CENTERVILLE CITY PLANNING COMMISSION AGENDA

Short Title: ADMINISTRATIVE DECISION - Final Site Plan - Bank of America

OWNER:	DEERWOOD INVESTMENTS UTAH LLC 3720 SOUTH SUSAN STREET #100 SANTA ANA, CA 92704 <u>msalcedo@acpmanagement.com</u>
CONTACT:	ORLANDO TAYOR <u>orlando_taylor@gensler.com</u>
PARCEL:	782 WEST PARRISH LANE (AKA: FORMER IGGY'S BUILDING- ISLAND PARCEL)
ACREAGE:	1.0 ACRES
ZONING:	COMMERCIAL – VERY HIGH (C-VH)
APPLICATION:	FINAL SITE PLAN APPROVAL (<i>SITE REDEVELOPMENT</i>)

PREVIOUS CONCEPTUAL SITE PLAN REVIEW & COMPLIANCE SUMMARY

Site Plan
Bank of America - Centerville
702 West Parrish Lane
Centerville, Utah

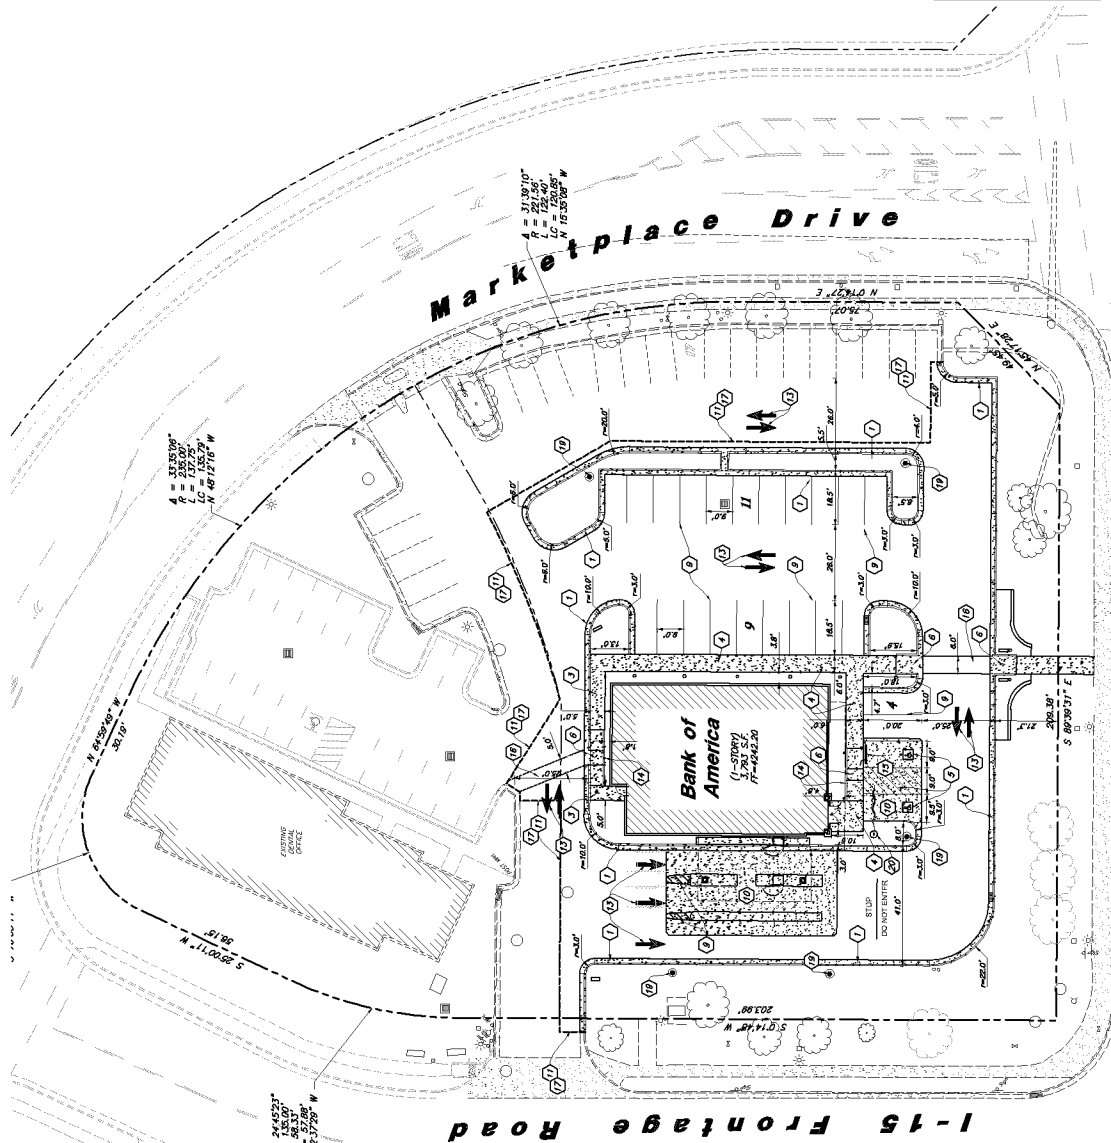
- c. The two-way drive isles need to be corrected from 24 feet to the Zoning Code required 25 feet in width [see CZC 12.52.310].
 - d. The Final Site Plan shall address the required "storyboard" regarding the use of colors, materials, expected articulation parameters and design features [see CZC 12.63.040].

- c. *The two-way drive isles need to be corrected from 24 feet to the Zoning Code required 25 feet in width (see CZC 12.52.310). **Complies – see Sheet C1.1 – Site Plan***
